## ADDENDUM No. 1

### Elmira Civil War Visitor Center

AJH Project # 25-086

**Addendum Issue Date:** 1/16/26

5-1.1

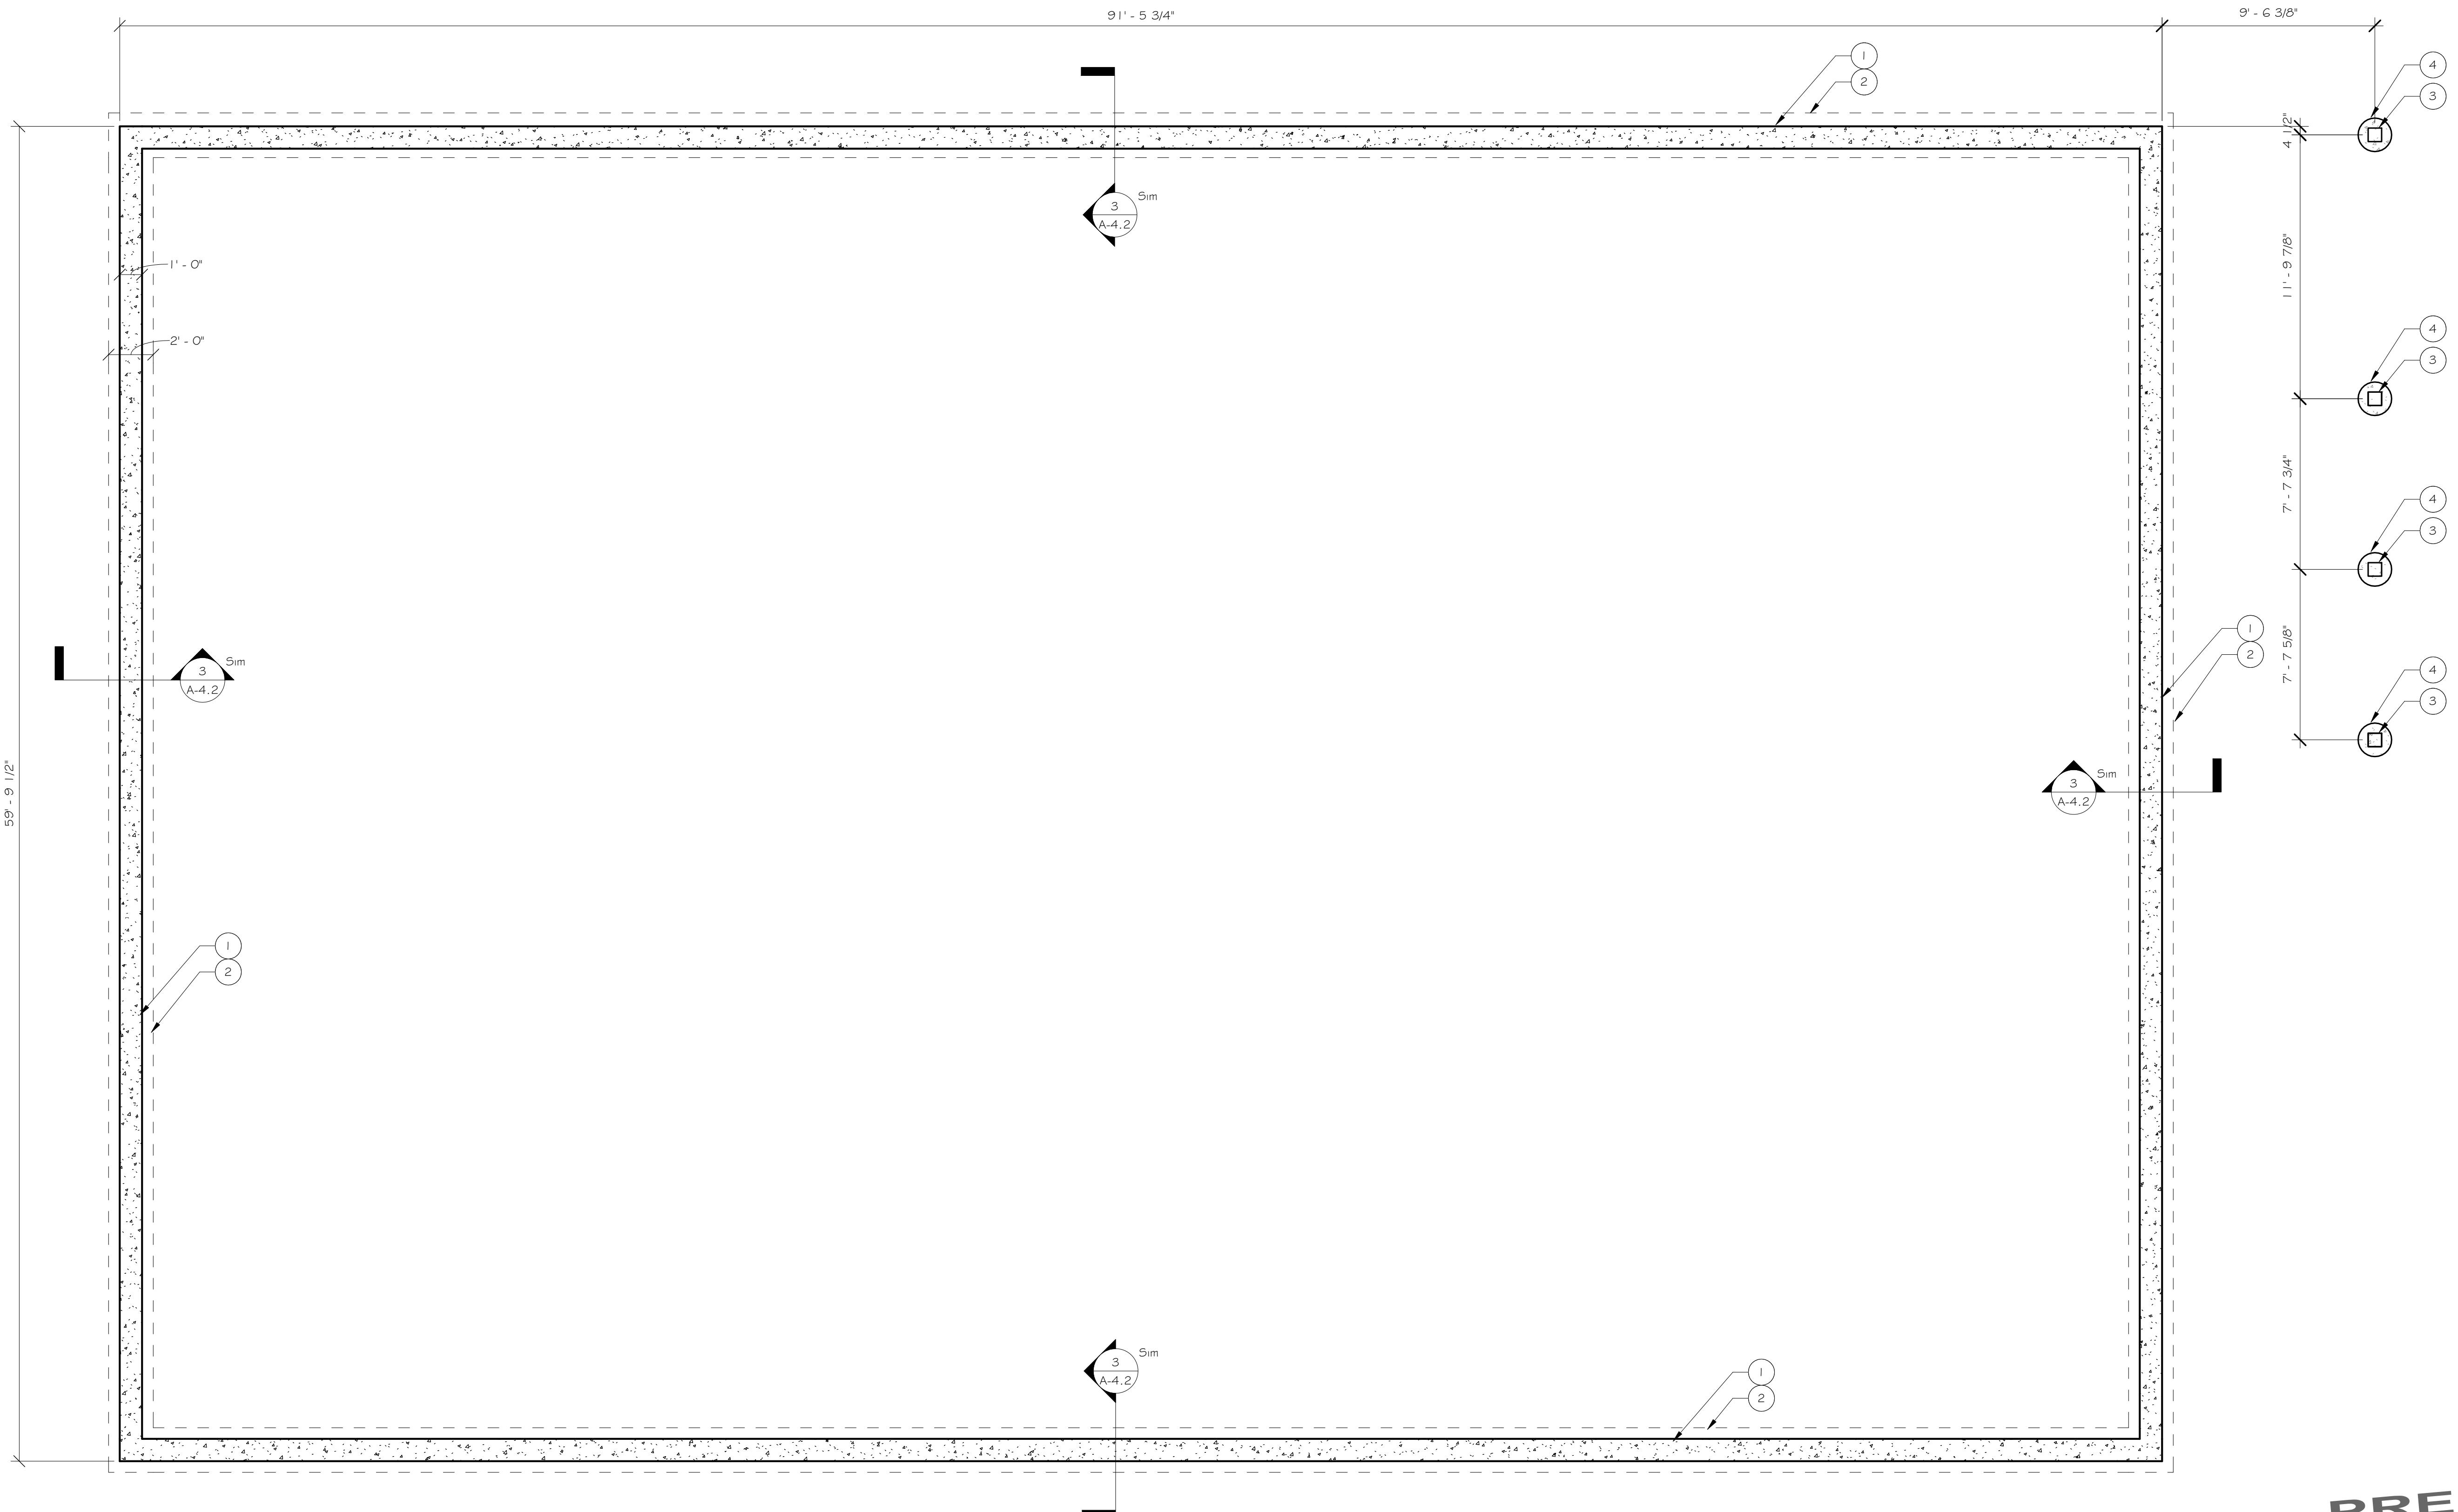
1. Electrical service will be 400 amp.
2. Foundation wall will be 12" poured concrete with rigid insulation. NO ICF. See updated structural drawings and sections.

4. S-1.1 Keynote 1 indicates 8" ICF foundation wall. Foundation walls will be as drawn on sheet A-4.2. 12" concrete foundation wall with perimeter rigid insulation along the foundation wall and below the slab extending 6' into the building. Disregard any notes referring to 8" ICF. These have been corrected on the attached revised foundation drawings S-1.1.

5. #4 rebar in foundation walls shall be #4 rebar vertical @ 24" OC and #4 rebar @ 18" OC.
6. The SOG will extend through the door entries only as shown in detail 2/A-7.1. At storefront windows the SOG will end at the foundation wall as shown in detail 6/A-4.2.

- 1 12" CONC. FOUNDATION WALL WITH #4 BAR VERTICAL @24" O.C. AND #4 BAR HORIZONTAL @ 18" O.C.
- 2 CONCRETE FOOTING 12" DEEP BY 24" WIDE WITH (3) #4 BAR CONTINUOUS
- 3 8 X 8 P.T. POST
- 4 18" SONOTUBE 4'-0" DEEP MIN.
